PRELIMINARY DRAINAGE REPORT
for
FALCON MARKETPLACE

January 17, 2017
Revised: June 18, 2018

Drexel, Barrell & Co.
3 South Seventh Street
Colorado Springs, CO 80905
Contact: Tim McConnell, P.E.
(719) 260-0887

D-1
 SHEET: 1 OF 1

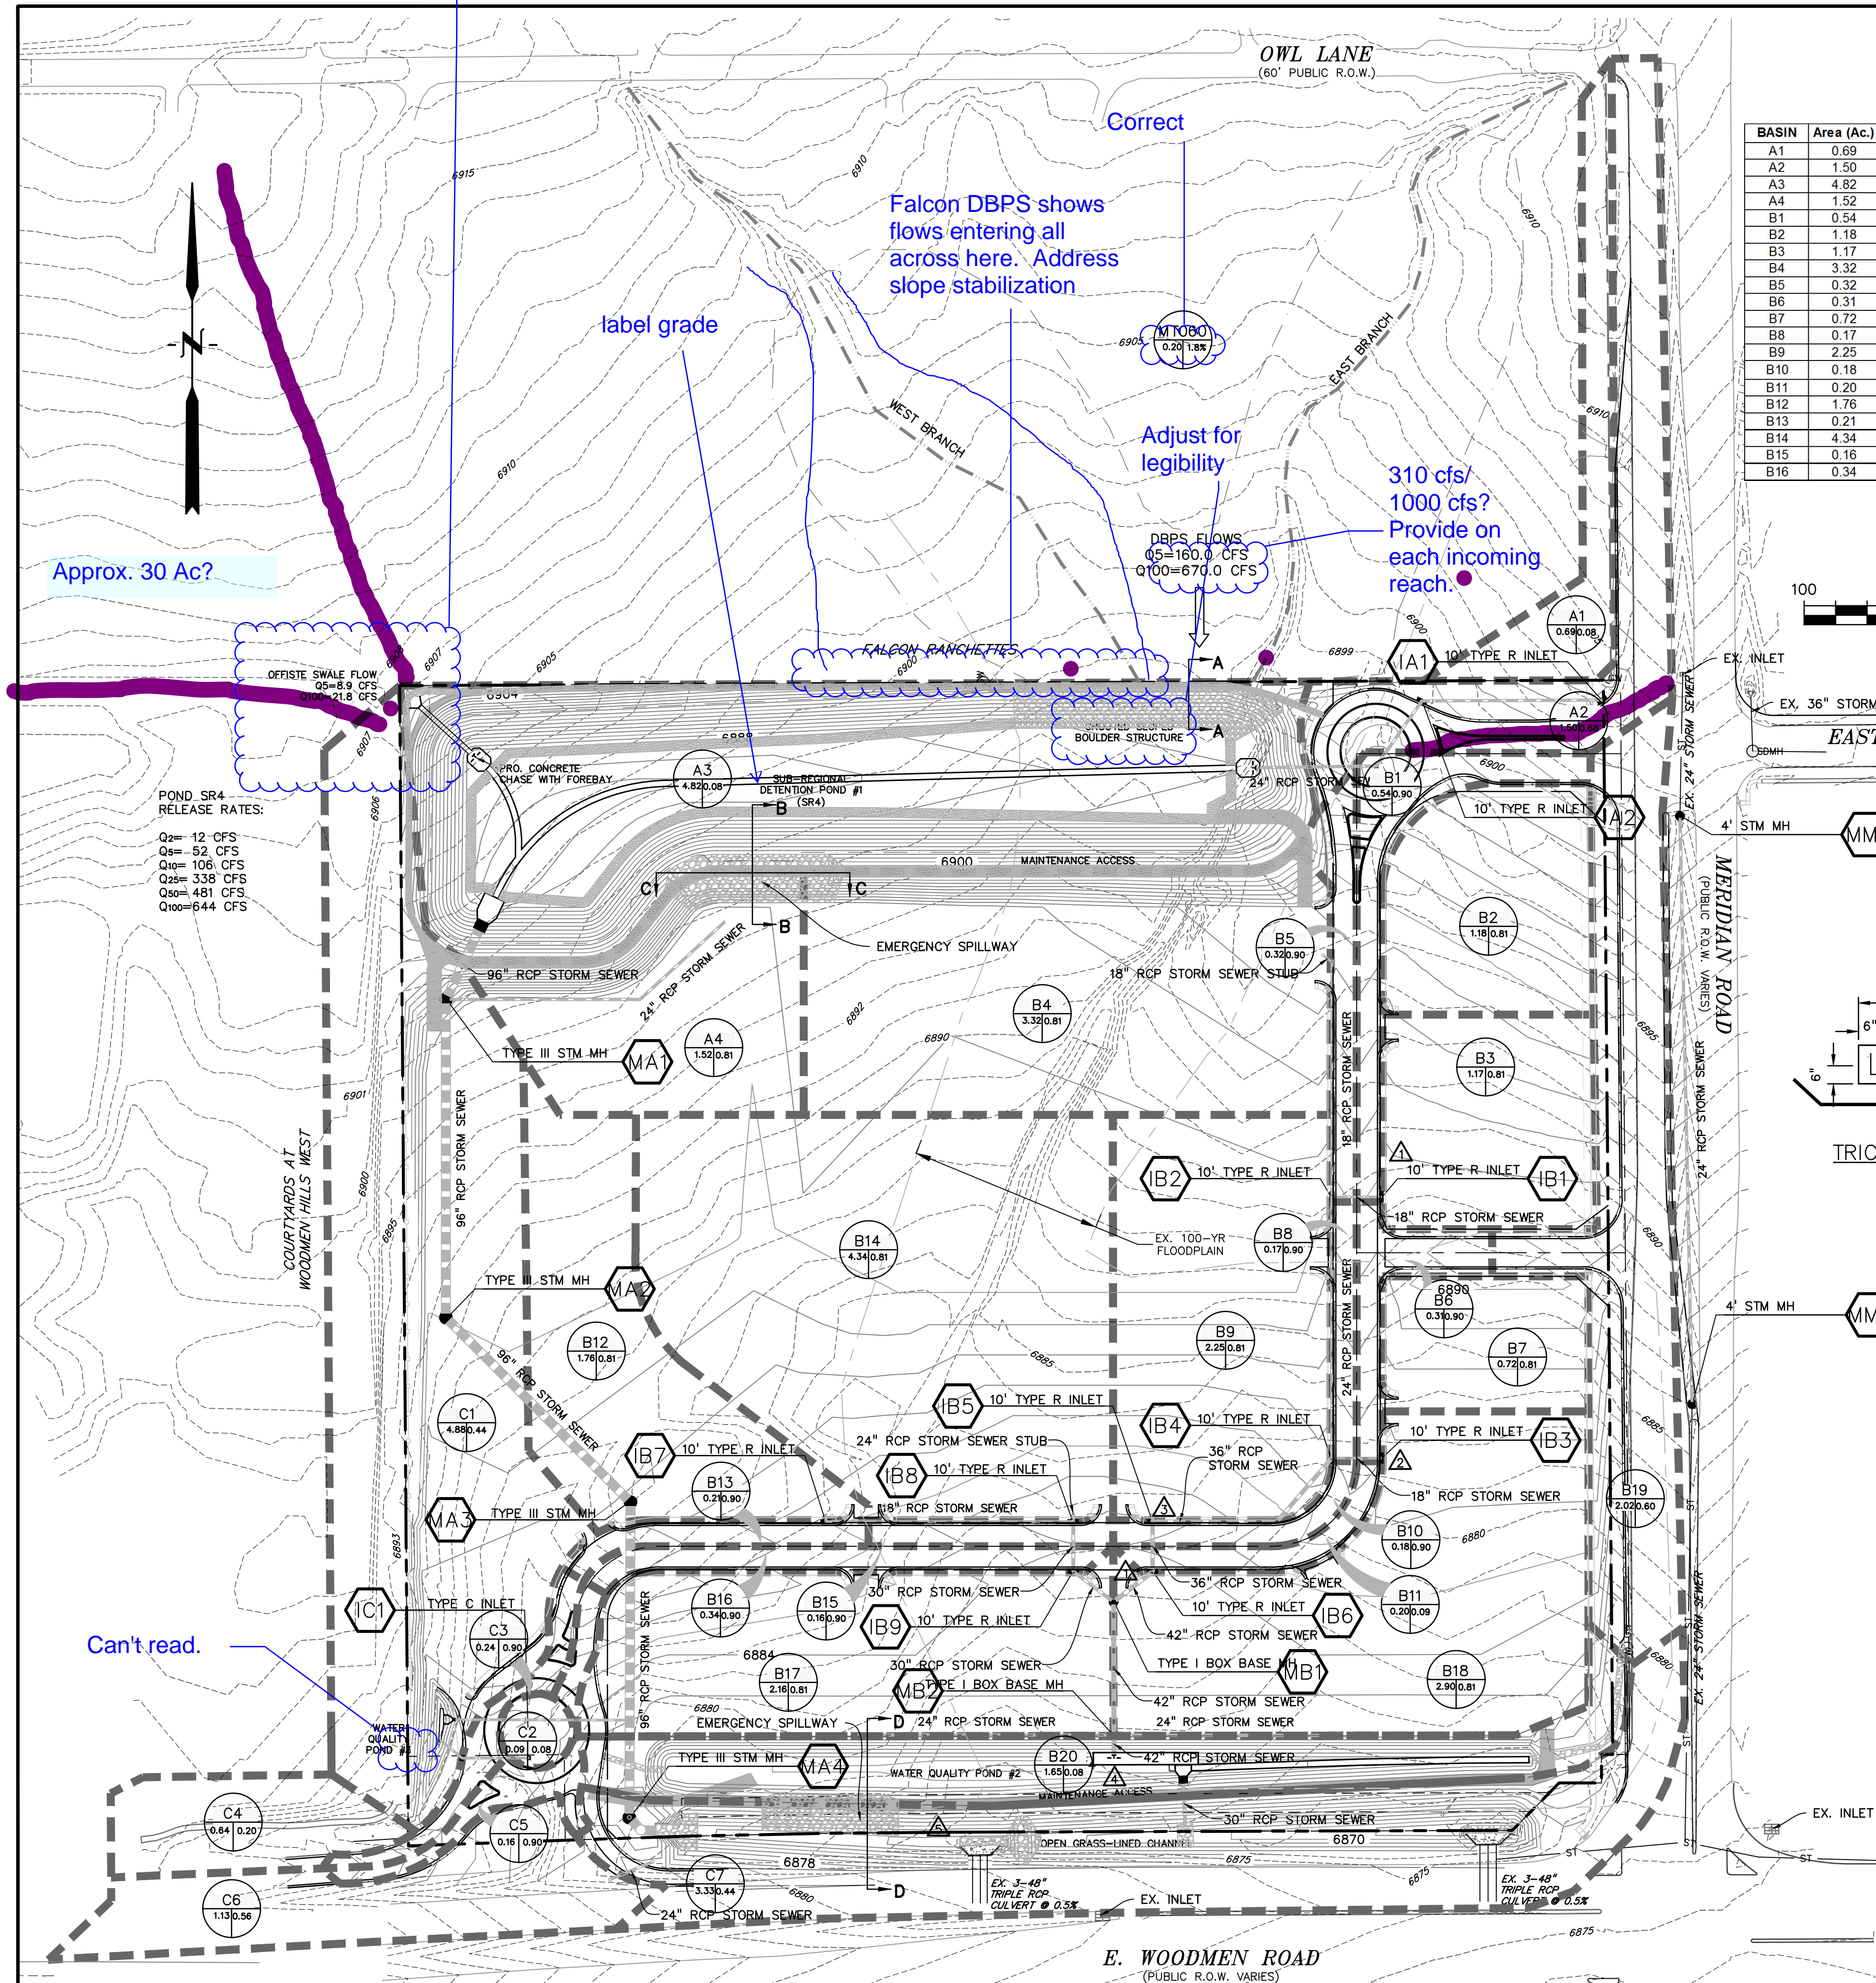
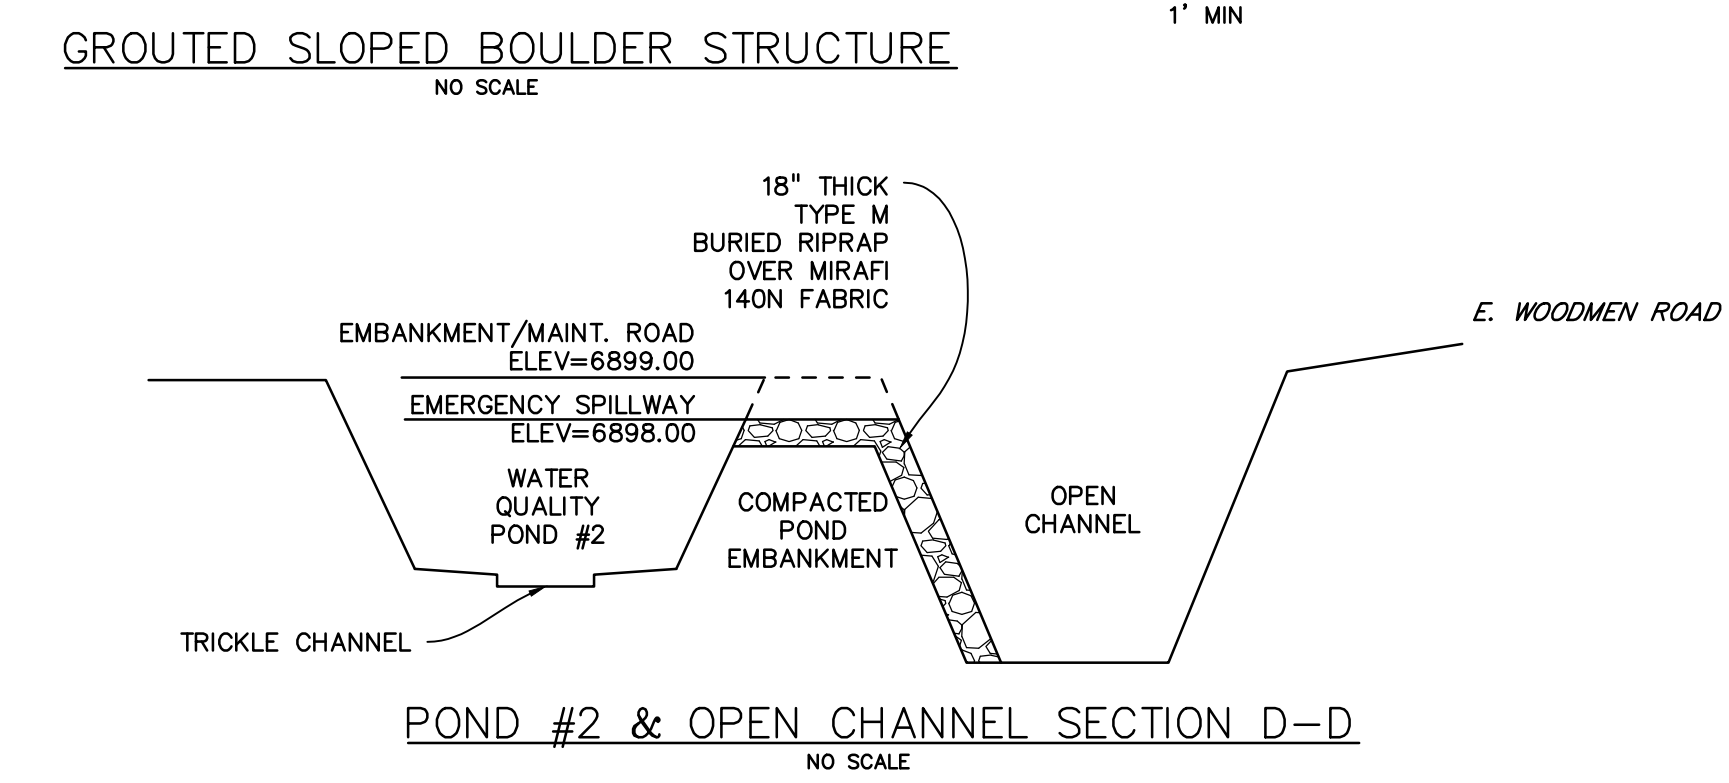
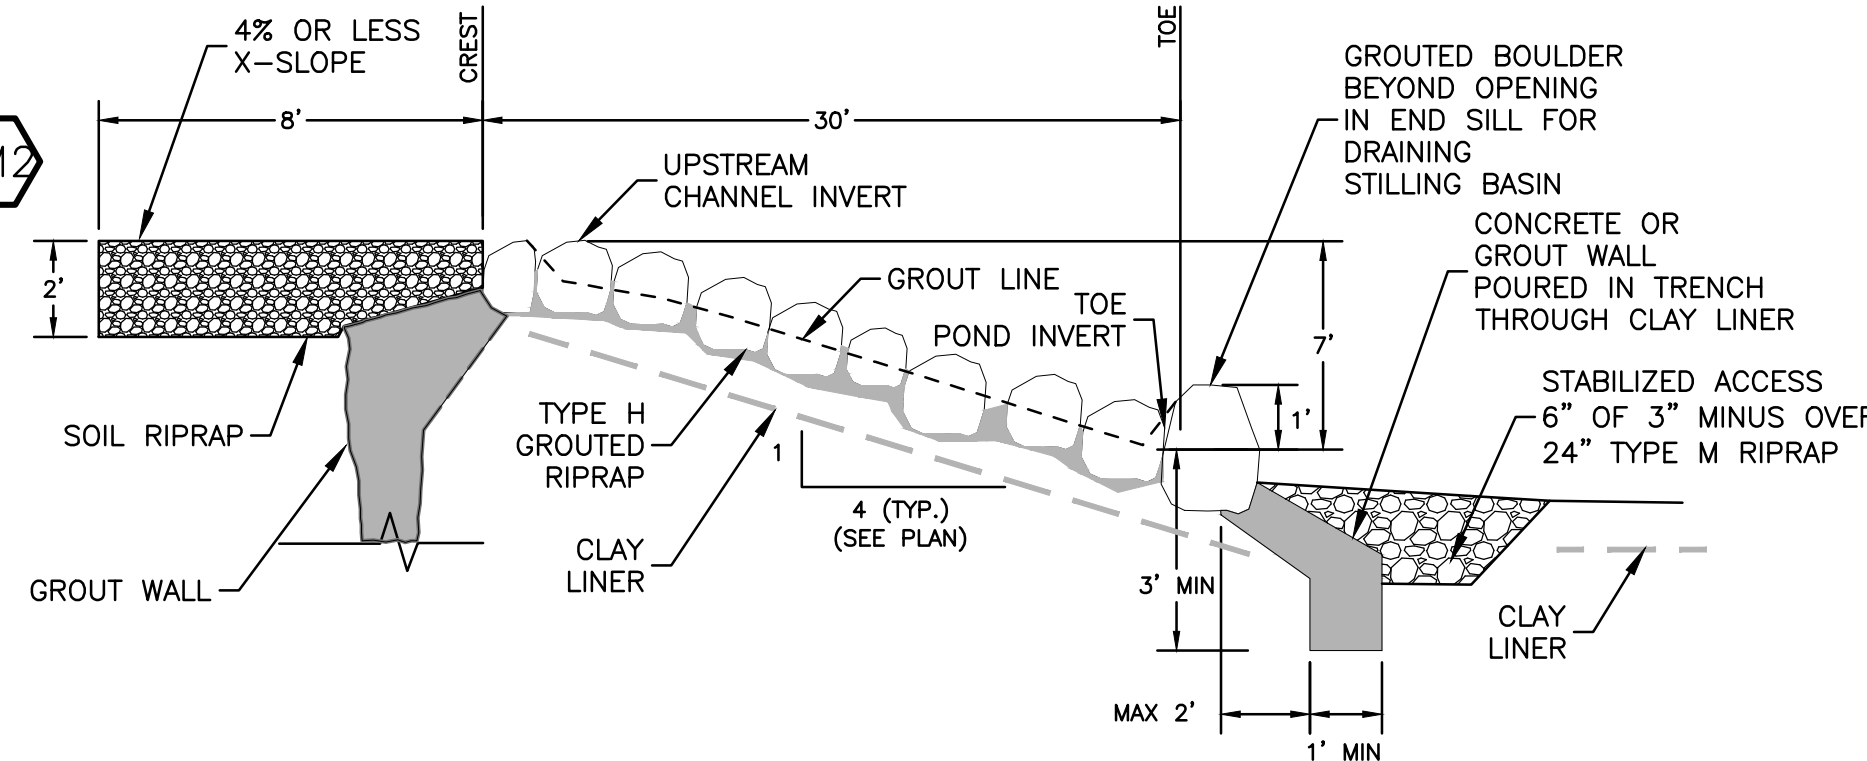
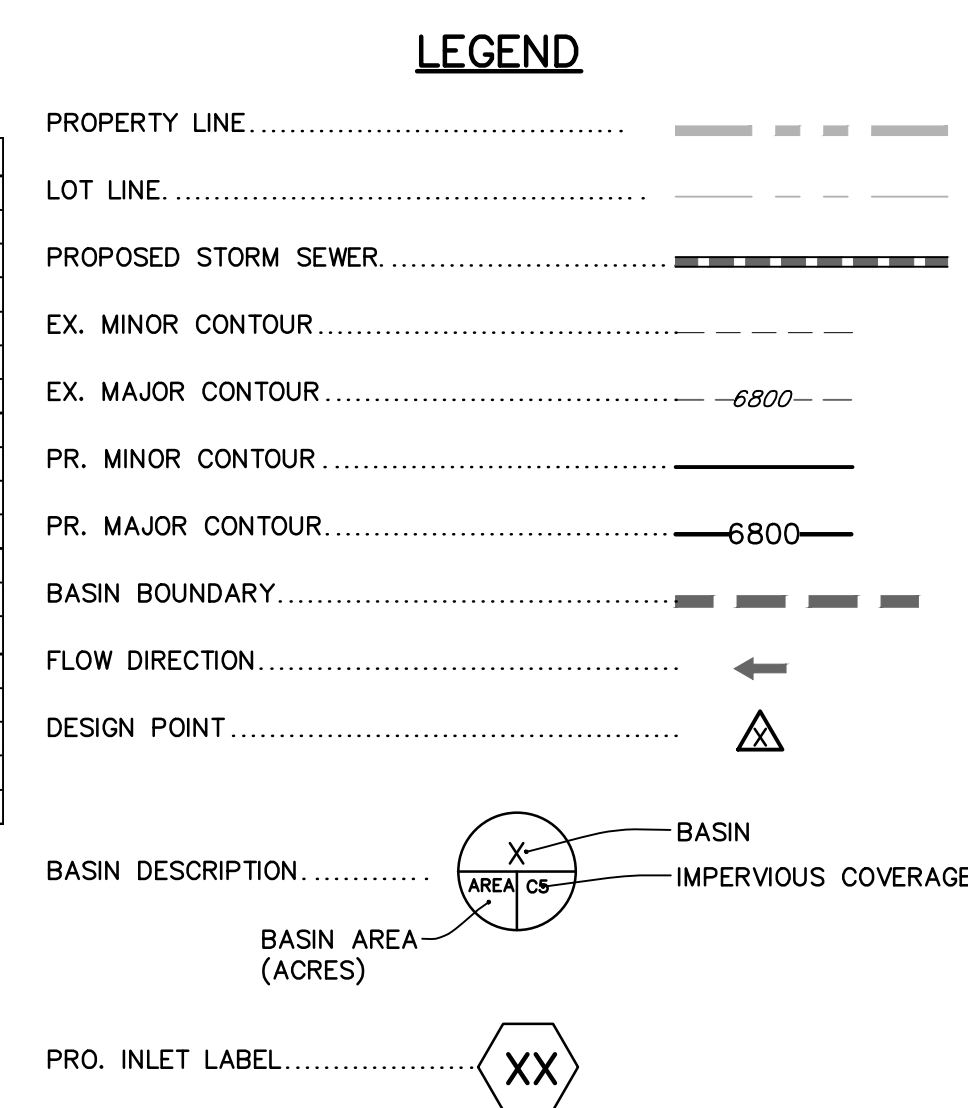
Provide detail showing grading to get swale into pond.

Show and label all offsite design points and sub-basins.

Provide calculations showing width and depth of flows entering pond at all applicable locations.

Approx. 30 Ac?

Correct

310 cfs/1000 cfs? Provide on each incoming reach.

Provide dimension
